## Stellaris<sup>®</sup> LM3S5B91 RevC5 Errata

This document contains known errata at the time of publication for the Stellaris LM3S5B91 microcontroller. The table below summarizes the errata and lists the affected revisions. See the data sheet for more details.

Figure 1. VDD Waveform Signature Limits

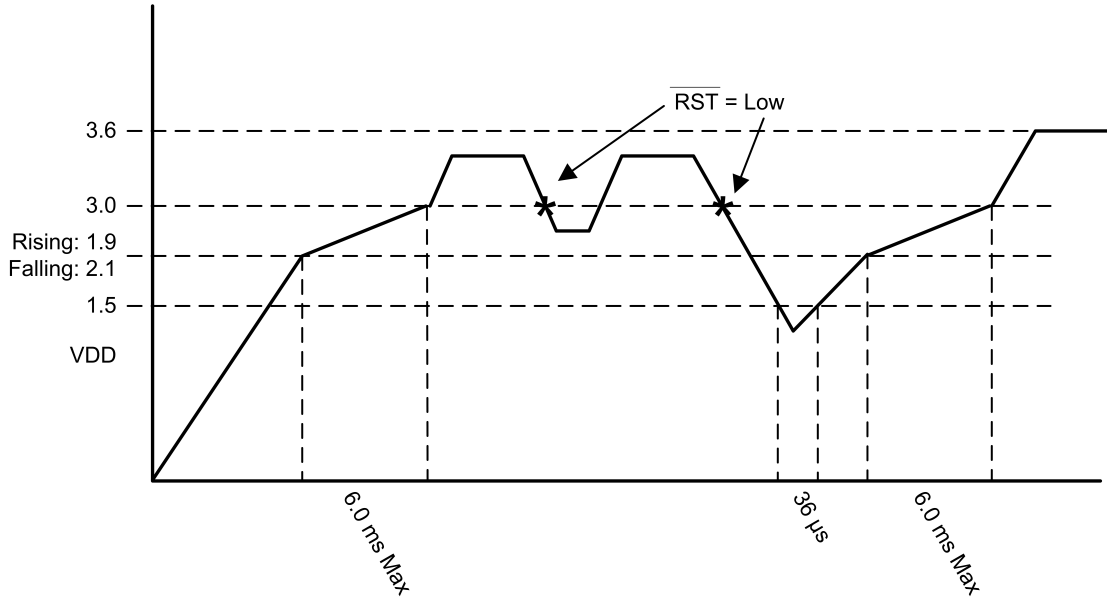
After initial power-up, any processor operation with VDD below 3.0 V may result in unexpected code execution resulting in the effects described above. The processor must be halted or the  $\overline{\text{RST}}$  signal must be driven Low prior to VDD dropping below 3.0 V and stay in that state until VDD is above 3.0 V.

If VDD falls below 2.1 V, it must continue to fall until it reaches 1.5 V. VDD must stay below 1.5 V for at least 36  $\mu\text{s}$  to ensure that a POR is triggered correctly. Additionally, the VDD power-up time between 1.9 V and 3.0 V must be at most 6.0 ms. If VDD falls below 3.0 V but stays above 2.1 V, it is not necessary for the voltage to continue falling below 2.1 V. VDD can come back up to 3.0 V without any additional timing requirements.

1. The VDD power-up, steady state, and power-down waveform meets the timing requirements shown in Figure 1 on page 14.
2. The power-up transition of VDD between 1.9 V and 3.0 V must not have any points where it decreases in voltage (must be monotonic).
3. The power-down transition of VDD between 3.0 V and 1.5 V must not have any points where it increases in voltage (must be monotonic).
4. Once steady-state operation between 3.0 V and 3.6 V is achieved,  $\overline{\text{RST}}$  must go Low or the CPU execution must be halted prior to VDD falling below 3.0 V.
5. The **Brown-Out Reset Control (PBORCTL)** register must be set so that a brown-out event causes a reset.

Figure 2. Using a Voltage Supervisor to Monitor the Voltage Rail

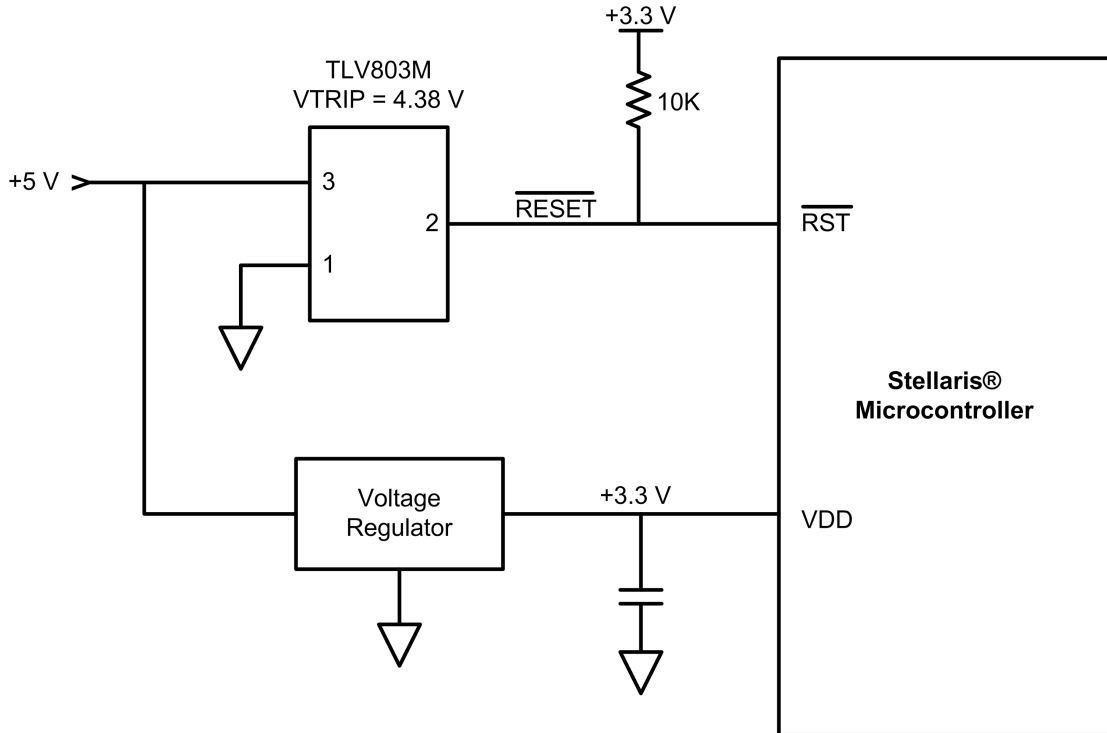
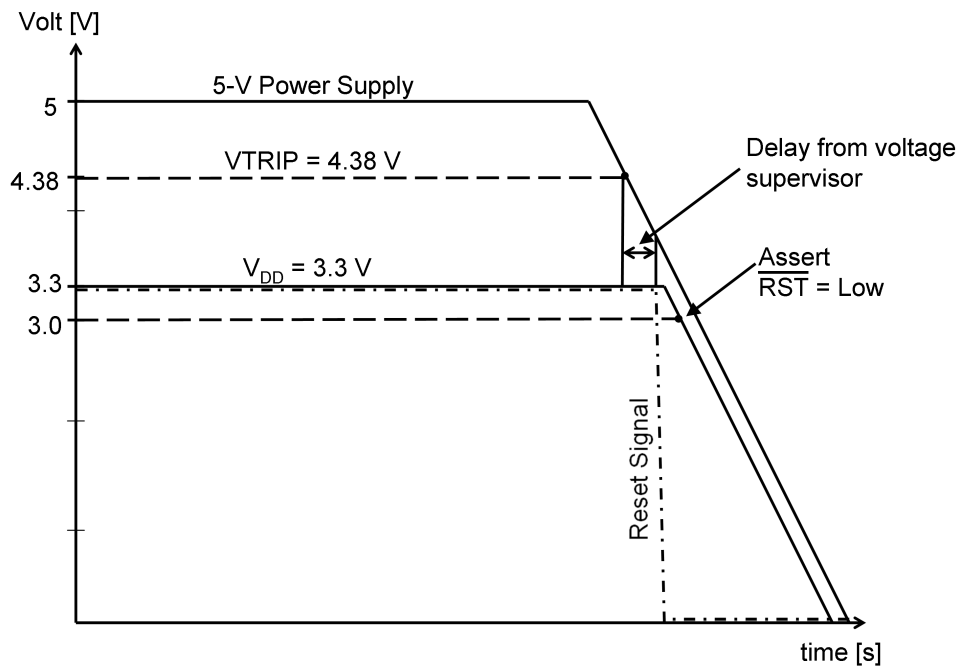
Depending on the system environment requirement, items 3, 4, and 5 in the above list may be met by using a voltage supervisor, such as the TLV803M, to monitor a higher voltage rail from which the VDD supply is regulated. Figure 2 on page 14 shows this implementation with a voltage supervisor monitoring the 5-V rail and a voltage trip point of 4.38 V. A voltage supervisor with a lower voltage trip point can be used to monitor the VDD (3.3-V) rail, however this supervisor must assert reset before VDD reaches 3.0 V. Regardless of the implemented voltage supervisor circuit, the system designer must ensure that there is enough time to assert  $\overline{\text{RST}}$  Low prior to VDD falling below 3.0 V. Figure 3 on page 15 shows the resulting waveform of the circuit shown in Figure 2 on page 14.

Figure 4. Example of USB Certification Failure

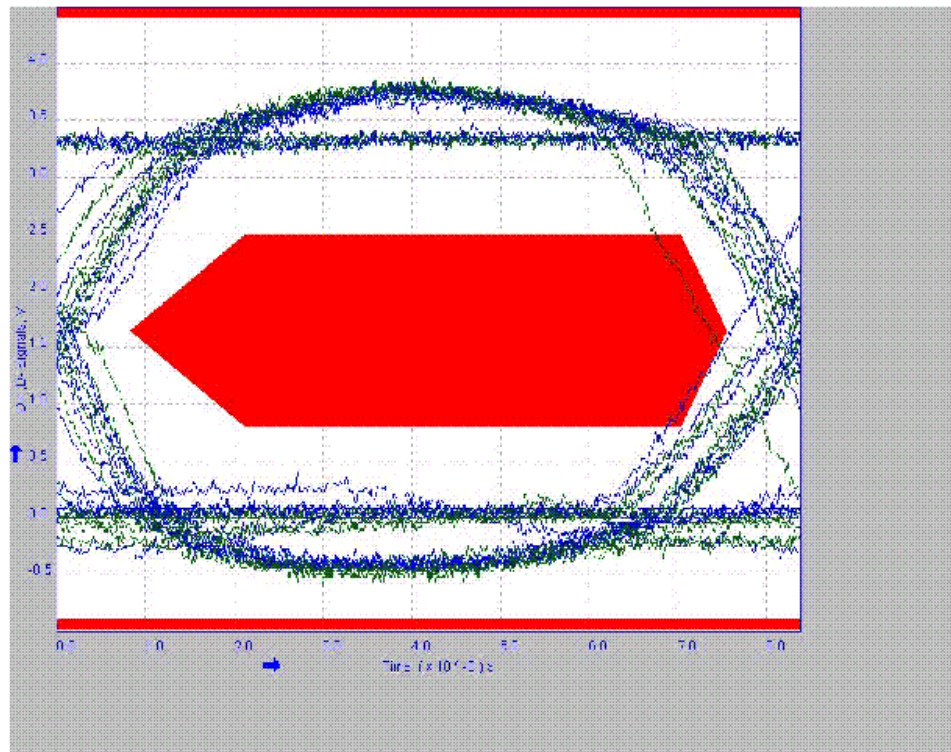
If the EPI module is operating, the USB interface may fail USB certification. Failures have been seen for the eye diagram and jitter (see Figure 4 on page 33). Because of these issues, there is a potential for data corruption on the USB interface when using the USB and EPI at the same time. The risk of data corruption is small, but is dependent on the system design.

- Signal eye:  
Eye Diagram Test fails

- EOP width: 169.0995ns  
EOP width passes
- Receivers: reliable operation on tier Tier 6  
Receivers pass
- Measured Signalling Rate: 11.92707Mbps  
signal rate conditionally passes
- Crossover voltage range: 1.546667 V to 1.680000 V  
Mean crossover = 1.615889 V  
First crossover at 1.660000 V(11 other differential crossovers checked)  
crossover voltages pass
- Consecutive jitter range: -165.1885ns to 1.811468ns, RMS jitter 52.27256ns  
Paired JK jitter range: 752.3810ps to 2.871429ns, RMS jitter 1.821542ns  
Paired KJ jitter range: 1.185714ns to 2.168571ns, RMS jitter 1.695397ns  
jitter fails
